AGENDA
CITY OF STURGEON BAY
CITY PLAN COMMISSION
Wednesday, August 16, 2017
6:00 p.m.
Council Chambers, City Hall
421 Michigan Street

Staff Report
Conditional Use for Multiple-Family Dwellings
Three 8-Unit Townhomes for Premier Real Estate Management

PREMIER AMITY FIELD TOWNHOMES CITY OF STURGEON BAY, DOOR COUNTY, WISCONSIN

SITE UTILITIES PLAN

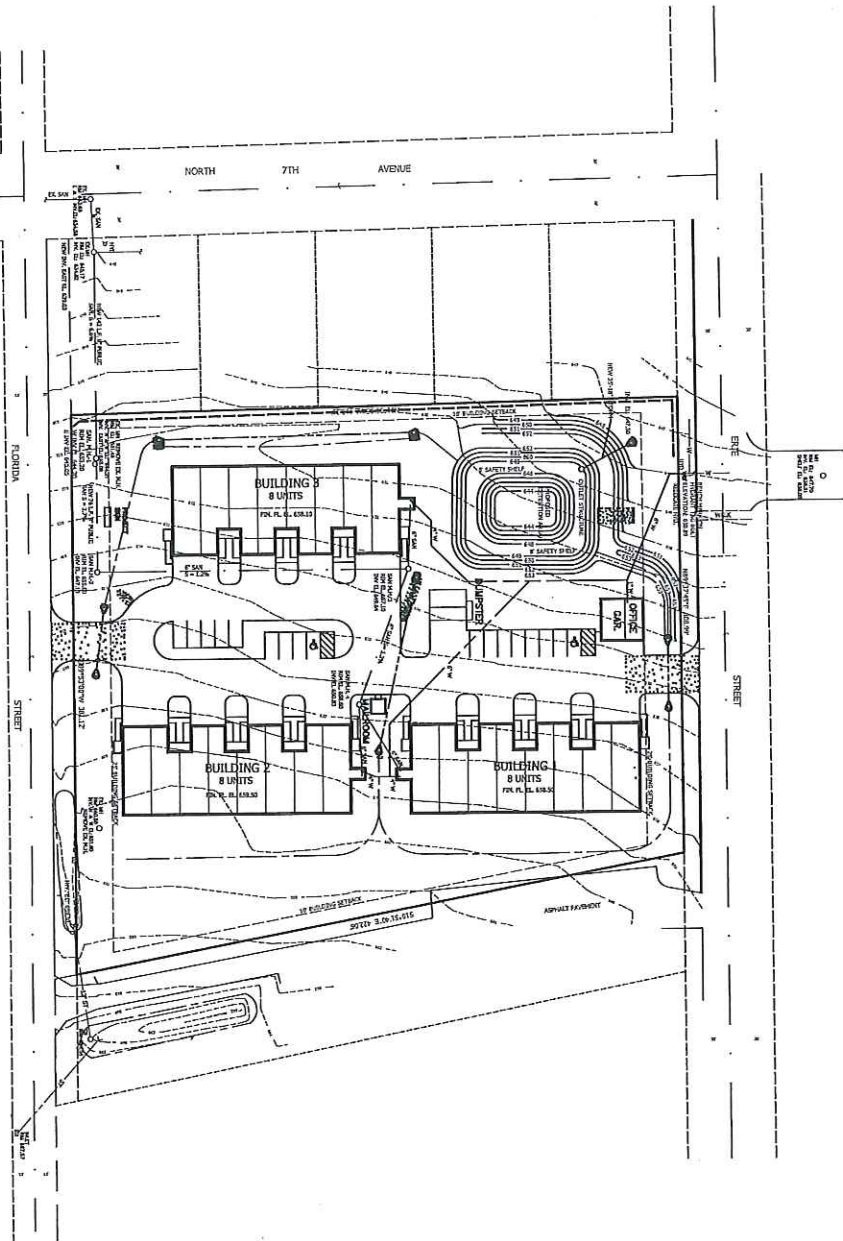
Utilities: The development will be served by municipal utilities. Sanitary sewer will come from the south side of the site. The developer proposes to replace an old unused sanitary main that runs parallel to Florida Street from 7th Avenue. It would then extend north through the site as a private main with laterals to the three buildings. Water would come from the north by extending into the site from the corner of Erie/7th Place. Again, it would be a private main with service laterals coming off the private main. Sturgeon Bay Utilities has reviewed the plan and is OK with it.

There is an issue with water for fire protection. Although the buildings will have fire suppression systems (sprinklers), the location of existing fire hydrants is still a concern. Building #2 is further than 300 feet from the nearest hydrant. The Fire Chief would like to see either a public hydrant on Florida Street by extending the water main from 7th Ave or a private hydrant lead coming off the proposed private main near the center of the site.

LANDSCAPE PLAN
SCALE 1" = 40'-0"

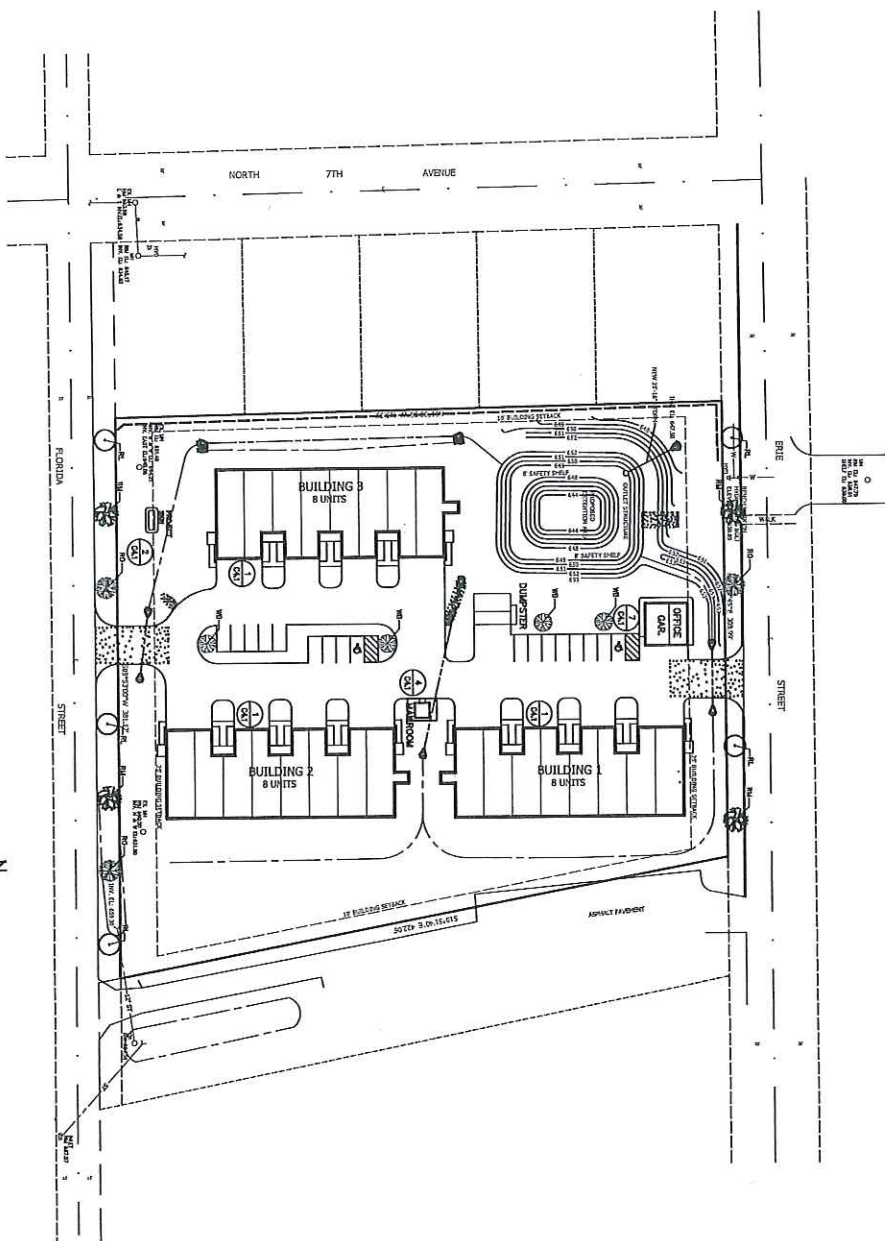
Landscaping: A landscaping plan was submitted. Regarding the parking lot landscaping, there is a strip of landscaping separating the two sides of the parking area by Buildings 2 and 3. In addition, there are 4 white birch trees proposed adjacent to the parking area. Thus, the parking lot landscaping requirement is met.

Street trees are required in the right-of-way at an interval of one for every 50 feet of frontage. The required 6 trees along Erie and 7 trees along Florida Street are shown in the plan. These are a combination of lindens, oaks, and maples. The City Forester is OK with the proposed species.

Regarding the rest of the landscaping, a variety of shrubs are proposed around the building foundations, including the office/garage and mailroom. Daylillies and shrubs are proposed around the sign. There are no specific standards for landscaping of the overall lot. Adding more trees, particularly at the ends of the buildings to enhance the plain side facade and for cooling in the summertime, is encouraged.

3 SIDE ELEVATION
SCALE: 1/4" = 1'-0"

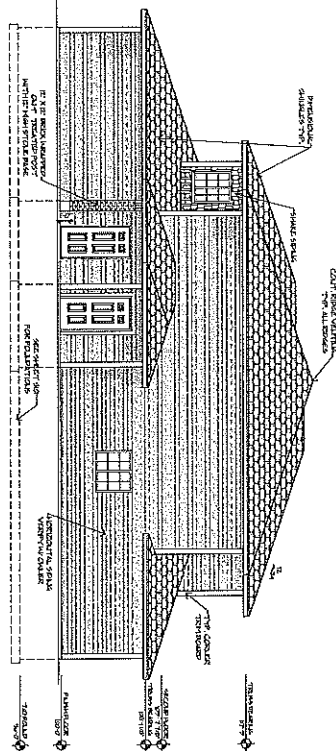
There are rear patios which are accessed by large sliding doors and separated by privacy walls. Windows are evenly spaced throughout the front and back facades with one window per unit, except that for the end units the window faces the side rather than the front. The side facade is pretty plain with one window and one entrance door. There also is a mechanical room on the side facing away from the street. Consideration should be given to enhancing the street facade, such as by adding a window(s), shutters, and/or architectural detailing.
